UNITED STATES PATENT AND TRADEMARK OFFICE

APPLICATION NO.	FILING DATE	FIRST NAMED INVENTOR	ATTORNEY DOCKET NO.	CONFIRMATION NO.
10/526,337	03/02/2005	Kenichi Nakamura	NAKA0102PUSA	8947
22045	7590	12/11/2007	EXAMINER	
BROOKS KUSHMAN P.C.			HUYNH, KHOA D	
1000 TOWN CENTER			ART UNIT	
TWENTY-SECOND FLOOR			PAPER NUMBER	
SOUTHFIELD, MI 48075			3751	
			MAIL DATE	DELIVERY MODE
			12/11/2007	PAPER

Office Action Summary

DETAILED ACTION

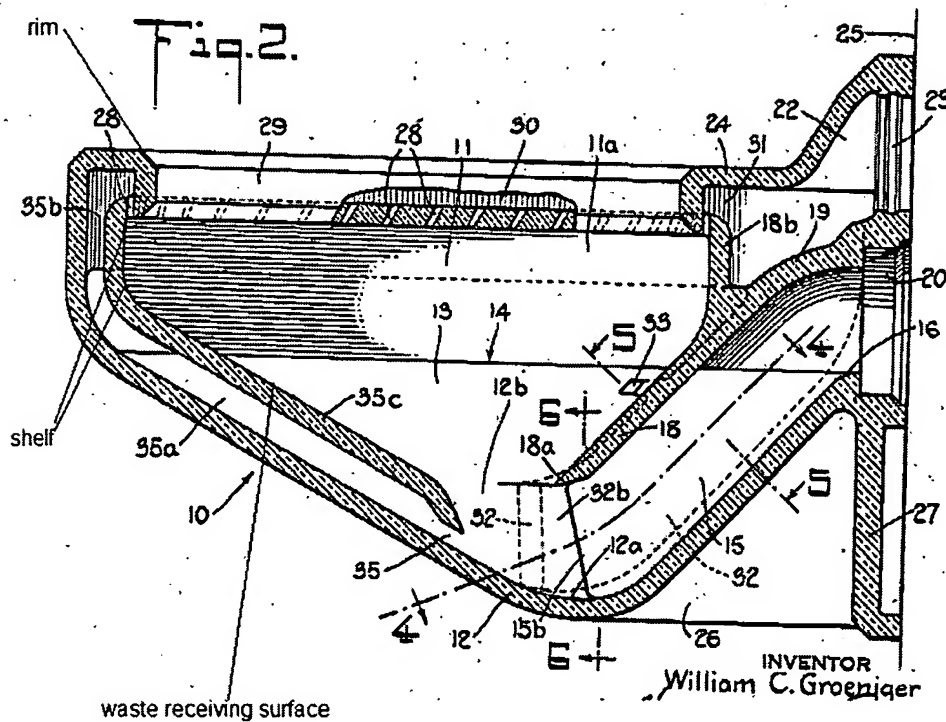
Regarding claim 1, the Groeniger reference discloses a flush toilet that uses a prescribed amount of cleansing water stored in a cleansing water tank to cleanse the toilet and discharge waste. The flush toilet includes a bowl (at 10) having a bowl-shaped waste receiving surface, a rim (*see above illustrations*) constituting an upper edge portion whose inner surface overhangs inward and a shelf (*see above illustrations*) formed between the rim and the waste receiving surface (Fig. 2), and a drainage channel (at 15) whose inlet is connected to the bottom of the bowl for discharging waste. A first water spouting section (at 32a on the left side) for spouting cleansing water onto the shelf of the bowl to form a

vortex; a second water spouting section (at 32a on the right side) for spouting cleansing water onto shelf of the bowl in the same direction as the swirling direction of the vortex; a first water channel (at 32 on the left side) for supplying cleansing water from the cleansing water tank to the first water spouting section; and a second water channel (at 32 on the right side) for supplying cleansing water from the cleansing water tank to the second water spouting section.

Regarding claim 2, as schematically shown in Figure 1, the second water channel makes a U-turn to communicate with the second water spouting section.

Regarding claims 3 and 8, the flush toilet further comprises a jet hole section (at 35) arranged to spout water toward the inlet (at 15b) of the drainage channel, wherein the amount of water spouted from the jet hole section is greater than the total amount of water spouted at the rim from the first water spouting section and second water spouting section (page 3, lines 13-17).

Regarding claims 4 and 5 (as best understood), as schematically shown in Figure 1, wherein the first water spouting section is installed on one side of the bowl relative to its fore-aft center axis at a point near a point where the radius of curvature of the bowl changes from a smaller value to a larger value and the second water spouting section is installed on the other side of the bowl at a point near a point where the radius of curvature of the bowl changes from a larger value to a smaller value, and wherein the amount of water spouted at the rim from the first water spouting section is inherently greater than the amount of water spouted at the rim from second water spouting section.

Regarding claims 10 and 11, as schematically shown in Figure 1, wherein the shelf of the bowl is formed to vary in width in a manner that causes the main stream of the cleansing water spouted the first water spouting section to flow toward the inlet of the drainage channel, wherein the width of the shelf of the bowl is formed wider at regions on opposite lateral sides of the bowl relative to its fore-aft center axis and formed narrower at the front end region of the bowl.

Secondly, as shown in *the above illustration* and stated in the above rejection, does disclose a flush toilet including a bowl (at 10) having a bowl-shaped waste receiving surface, a rim, a shelf (*see above illustrations*) formed between the rim and the waste receiving surface (Fig. 2), a first water spouting section (at 32a on the left

side) for spouting cleansing water onto the shelf of the bowl to form a vortex; a second water spouting section (at 32a on the right side) for spouting cleansing water onto shelf of the bowl in the same direction as the swirling direction of the vortex.
